Corporate Environmental Programs  
General Electric Company  
110 Woodlawn Avenue, Pittsfield, MA 01201

August 19, 2004

**Re: GE-Pittsfield/Housatonic River Site  
Hill 78 Area-Remainder (GEC160)  
Addendum to Pre-Design Investigation Work Plan**

FIGURE  
**1**

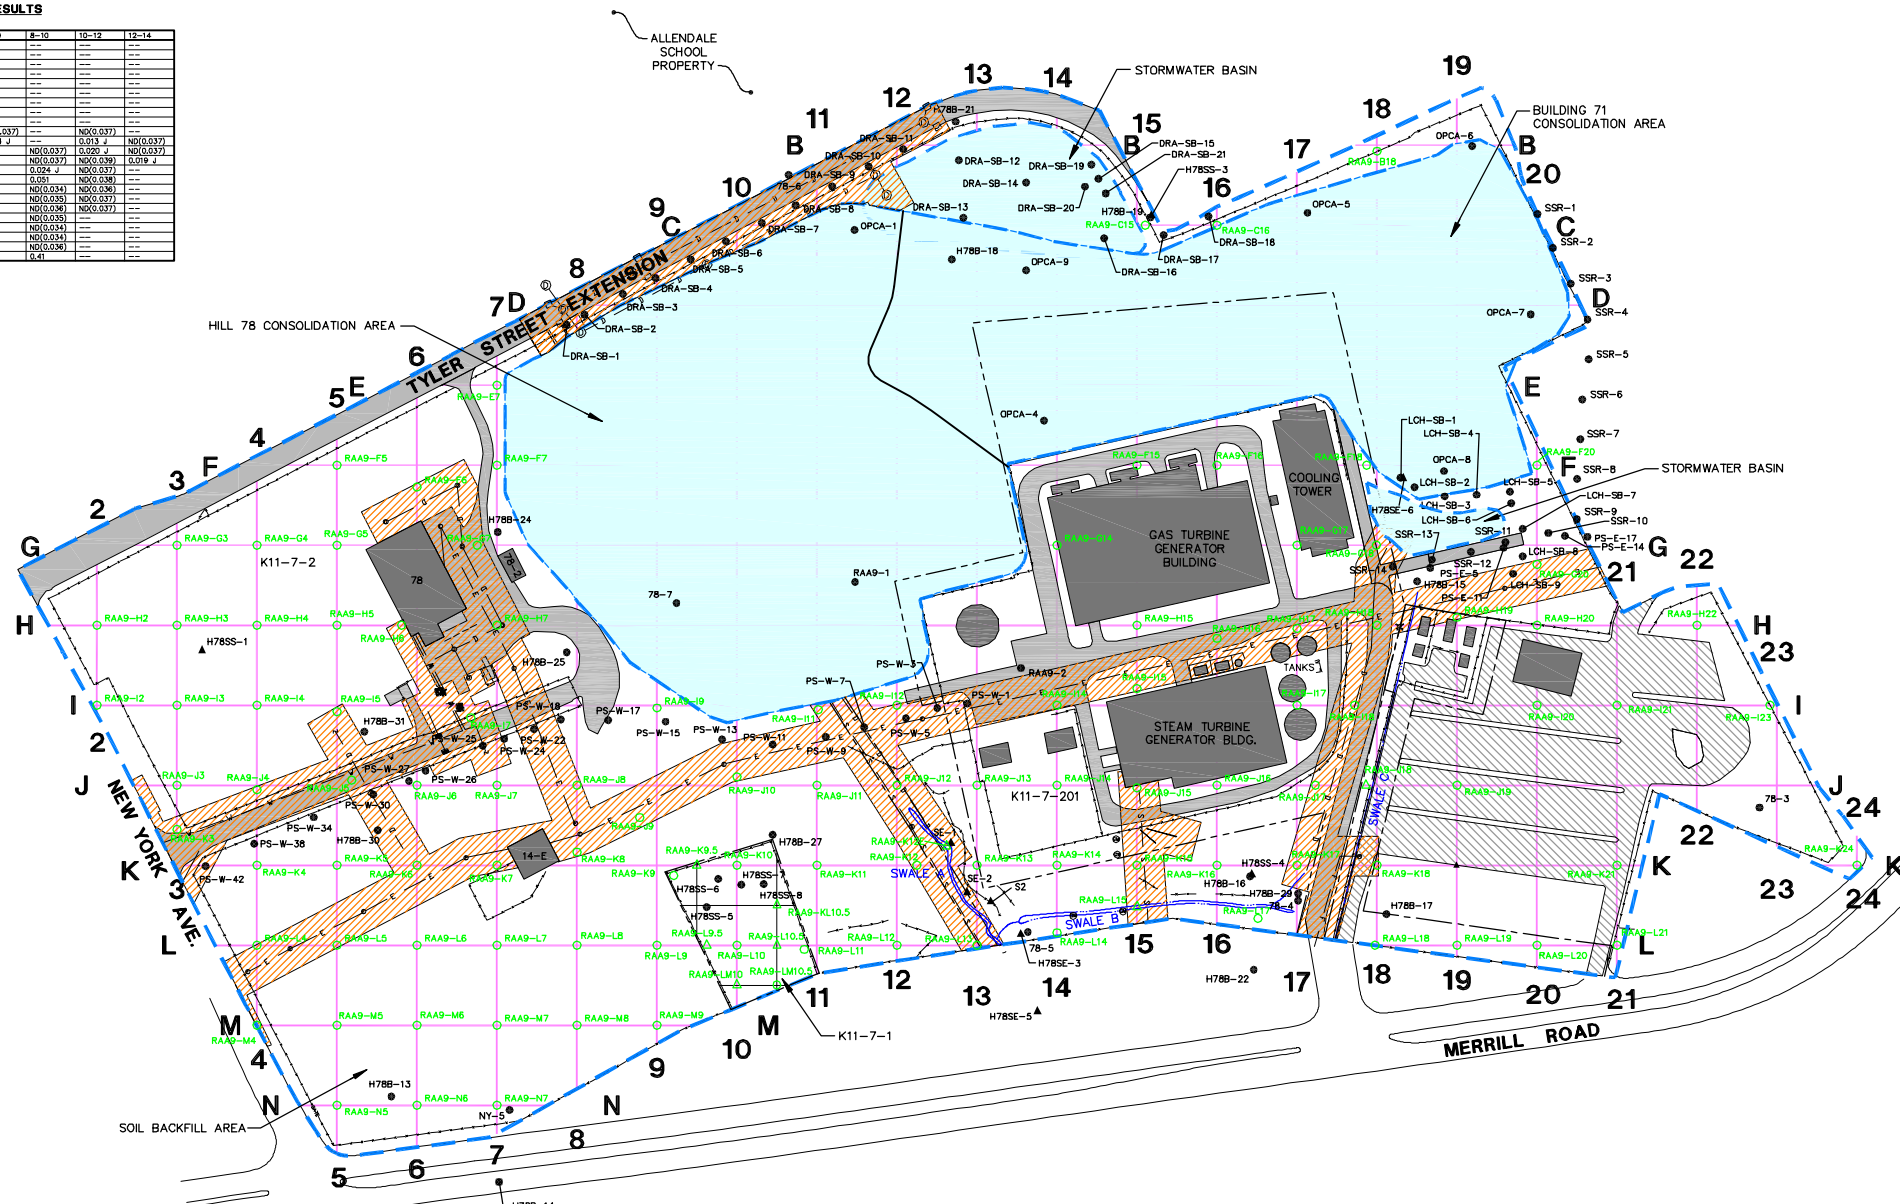
- In Condition 5, EPA states that additional characterization is required within certain utility corridors within the RAA. To address utility characterization within the utility corridors to the west and north of the Steam Turbine Generator Building, GE will shift proposed sample location RAA9-K12 approximately 25 ft to the east of the grid node, within the utility corridor and will add a boring at location RAA9-H17. Also, GE will move boring RAA9-G7 approximately 25 ft to the west of the grid node into the utility corridor to the east of Building 78.

- In Condition 7, EPA indicates that the three drainage swales within the Hill 78 Area-Remainder (Drainage Swales A, B, and C) require additional investigation. To address this data need, GE will add surface soil sampling locations to be analyzed for PCBs and Appendix IX+3 constituents (excluding pesticides and herbicides) at the following locations: RAA9-K12E -- near former boring location SE-1 in Drainage Swale A; RAA9-L15 in Drainage Swale B; and RAA9-J18 in Drainage Swale C.

- In Condition 3, EPA agrees with GE's proposed sampling approach to evaluate the non-GE-owned Parcel K11-7-1 as a separate averaging area, utilizing the Performance Standards applicable to the non-GE-owned commercial/industrial parcels at Unkamet Brook and East Street Area 1-North with EREs (including performance of PCB soil characterization on an approximate 50-foot grid for the 0- to 1-foot depth interval and on an approximate 100-foot grid for the subsurface depth intervals), subject to certain modifications. Specifically, proposed boring RAA9-K9 will be moved approximately 15 feet southeast to the corner of the parcel boundary. Proposed boring RAA9-L11 shall be moved approximately 10 feet to the west to the parcel boundary. These relocations are intended to allow PCB data from these borings to be utilized for both averaging areas. In addition, previously-proposed surface soil sample location RAA9-LM10.5 at the southern boundary of the parcel will instead be installed as a soil boring.

- Shift proposed boring RAA9-J9 south to prior boring location 2N;
  - Shift proposed boring RAA9-L17 northeast near prior boring location L-7 and collect the Appendix IX+3 sample from the 1- to 6-foot depth increment instead of from 0- to 1-foot depth increment as previously proposed;

- Collect an Appendix IX+3 sample from 1- to 6-feet at boring RAA9-F18, instead of from boring RAA9-F20; and
  - Collect an Appendix IX+3 sample from 0- to 1-foot at boring RAA9-G18, instead of from boring RAA9-G20.

Based on the foregoing considerations, GE proposes to collect and submit soil samples for analysis of PCBs and/or one or more groups of Appendix IX+3 constituents at the locations and depths shown on attached Figure 1 (for PCBs) and Figures 2 through 4 (for non-PCB Appendix IX+3 constituents) and listed in Table 1. A summary of the numbers of existing, proposed, and total PCB and non-PCB Appendix IX+3 characterization samples is as follows:
